**Roof Replacement - 2024**  
**Project No. 24006**

## **ADDENDUM NO. 2**

#### **Sheet A.300 CAMPUS ROOF REPLACEMENT PLAN & DETAILS**

**PAULDING COUNTY HOSPITAL**  
 1035 West Wayne Street, Paulding, OH 45879  
**Asphalt Shingled Roof Replacements**

5 **NRCA OPEN VALLEY (METAL LINED)**  
 A.300 12" = 1'-0"

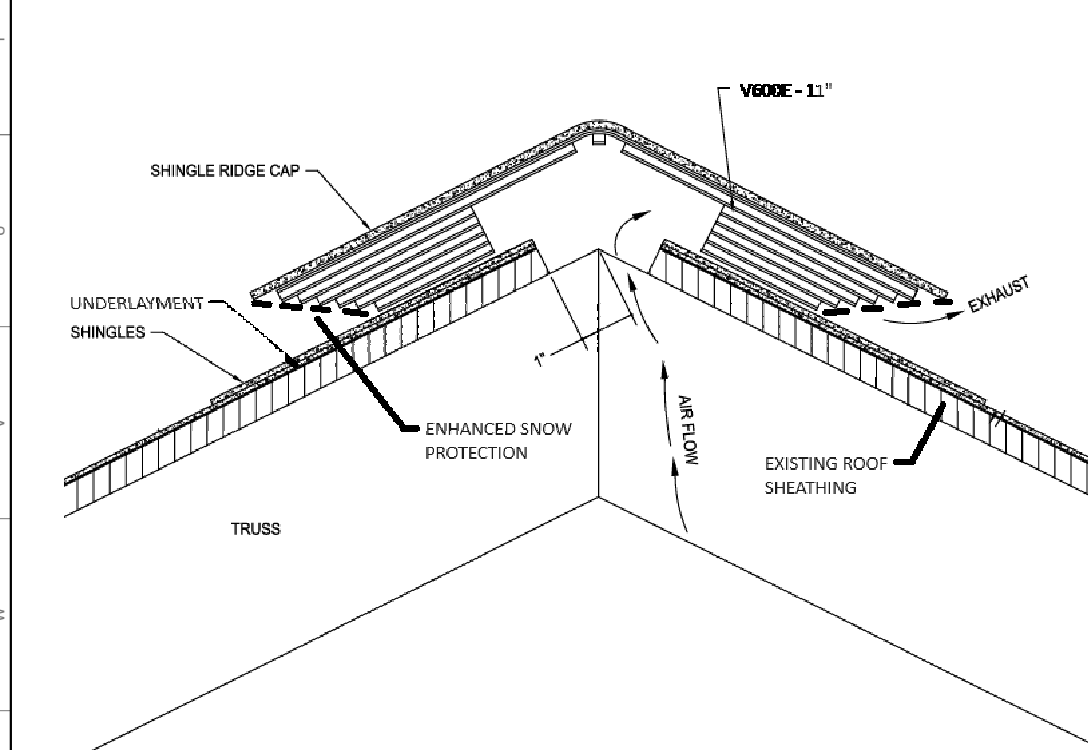
1. Types of valleys on the roof project (see keynotes, updated on the plan) Clarification:
  - a. Woven Valleys: are not intended anywhere on this project.

- b. Base Bid Roof Areas (main hospital building) there are both open (metal-lined) and closed cut valleys.
    - 1) Closed-Cut Valleys: Short run valleys (including penthouses) are intended to be of this type.

- 2) Open (metal-lined) Valleys: Longer run valleys are intended to be of this type.
  - c. Alternate Bid Roof Areas (out buildings) are intended to have Closed-Cut Valleys (where they exist).

3 **NRCA STD. BACKER FLASHING**  
 A.300 12" = 1'-0"

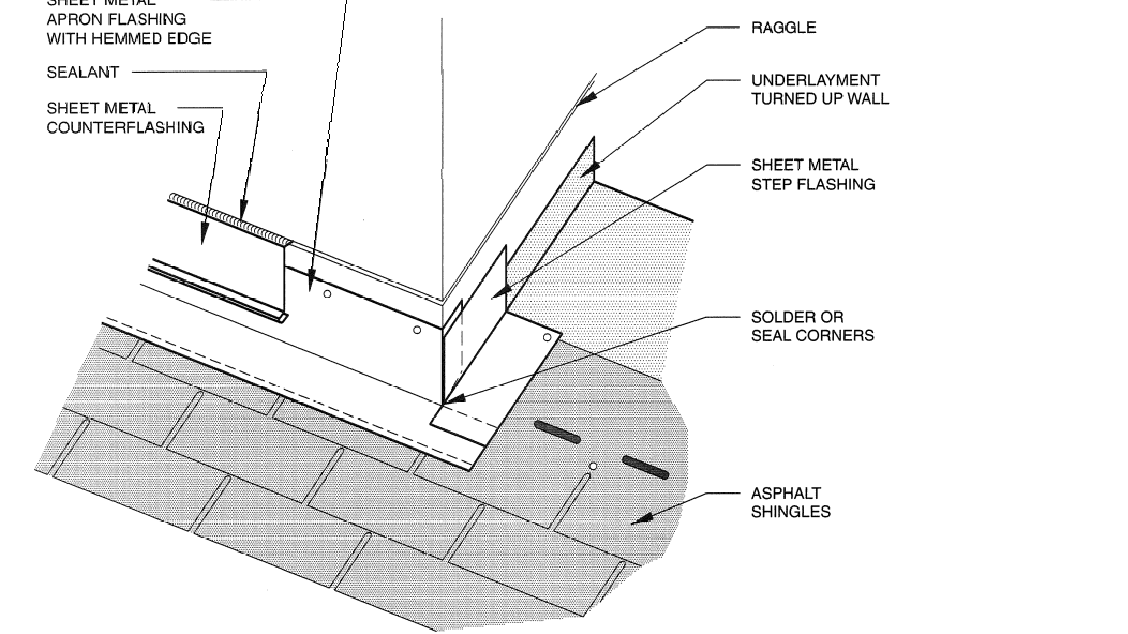
2. Flashing of Existing Mechanical Curbs Clarification:
  - a. Provide and install new prefinished metal flanged crickets on the uphill side of all existing mechanical curbs.

- b. Provide step flashing on all sloped sides of existing mechanical curbs.
  - c. Provide apron flashing lapped over shingles on the downhill side of all existing mechanical curbs.

- d. Provide perimeter prefinished metal counterflashing at perimeter of all existing mechanical curbs to completely conceal and protect curbs from inclement weather.

- e. Seal all new fasteners and all existing fasteners at existing curbs, exhaust fans, and curb adapters.
  - f. Replace detail 3/A.300 in its entirety as indicated on the plan.
